MEMORANDUM

To: The Design Advisory Board
From: Mary O'Neil, AICP, Principal Planner
RE: 75 Cherry Street; ZP21-0414CA
Date: January 26, 2021

File: 21-0414CA; Amendment to ZP17-0662CA/MA

Location: 75 Cherry Street (Burlington City Place)

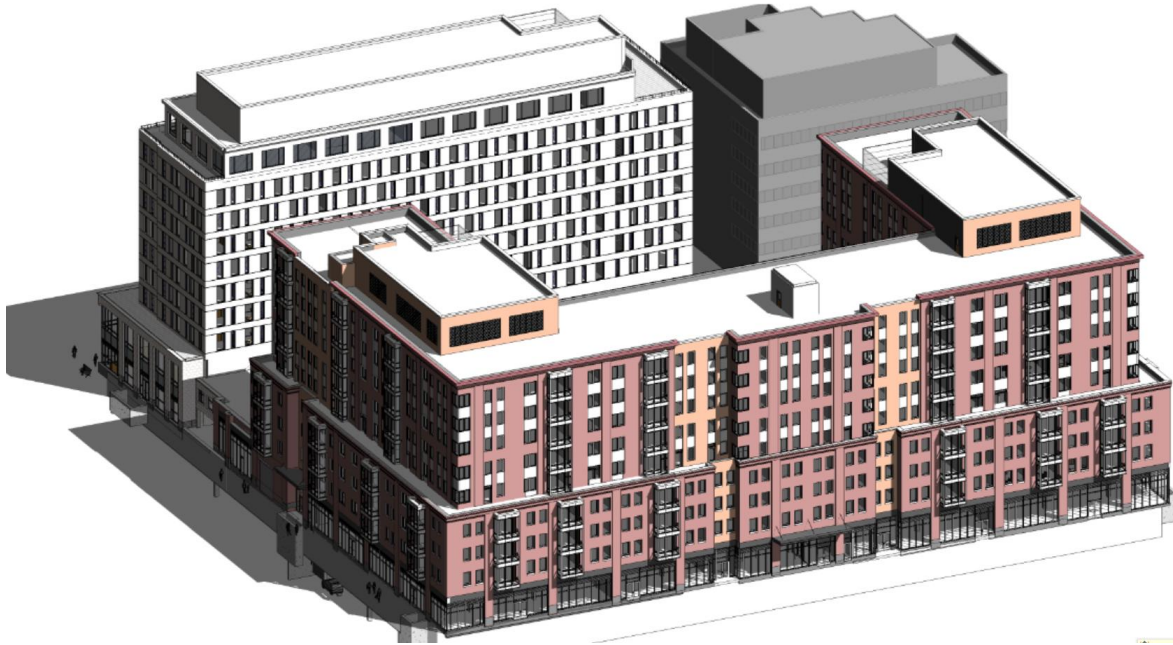
The building volume of the north residential building steps back at the 5th floor and is vertically accentuated with changes in the building plane, arrangement of windows, and introduction of varying primary materials. The roofline is accentuated with a bold cornice projection on different planes, breaking the massing up into readable building volumes. The cornice both caps the massing, and leads the eye down the street supporting and strengthening the street plane. The pedestrian level is enhanced with broad glazing to welcome and warm the streetfront energizing the pedestrian experience; strong material interplay delineates both building volume and division of segregate spaces. Vertical masonry piers draw the eye upward linking the lower pedestal to the upper, recessed stories.

The southern residential building has a defined and welcoming street presence, with a first and second story height that both strengthen the street wall as they mime the building heights of the existing buildings across Bank Street. The changing grade allows for the minimum 33' height to enforce that street wall. The massing steps back above this floor, with a more uniform material palette that continues the vertical pier element seen in the northern building. The feeling is light and buoyant; a silvery silhouette on a largely glass pedestal. Both building volumes establish points of reference for visual orientation; and provide optical interest and human scale at the pedestrian level through the use of step backs, horizontal and vertical variation, selection of materials, and other architectural design techniques to reinforce the street wall and reduce the perceived height and mass of upper stories from the street level.

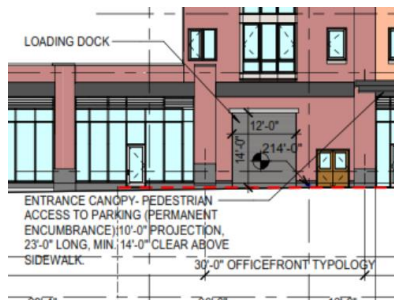
Loading and service overhead doors are not on the Primary Frontage, but on secondary Facades (St. Paul, Pine, and Bank Streets.) The applicant asserts that doors 12' in width may not be possible due to truck maneuvering clearances and the width of the newly planned streets. An additional complication is Natural Gas (Vt. Gas) at grade service. This requires areas of solid façade adjacent to St. Paul St. Meters will be located in special rooms within the docks and designed in conjunction with Vt. Gas to meet service requirements with minimal variation from the Form Based Code regulations.

The 20% allowable DRB relief would accommodate a door width of **14' 4¹³/₁₆"**.

The Bank Street loading dock was previously approved under 17-0662CA/MA as two openings, each 20'6" wide. The Bank Street loading dock may therefore be permitted up to that width.

Pine Street parking access, detail.

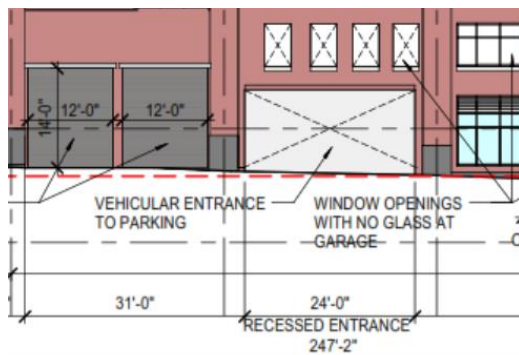
Although the plan set illustrates parking entries to be 24' in width, the applicant acknowledges that it may not be functionally possible. The two newly established streets (St. Paul, Pine) are quite narrow, and the Parking flow study for parking volumes in conjunction with the traffic study test the width limitation. A 20% maximum relief would offer an additional 4.8' width allowance or a maximum of **28' 9 ¹⁹/₃₂"**.
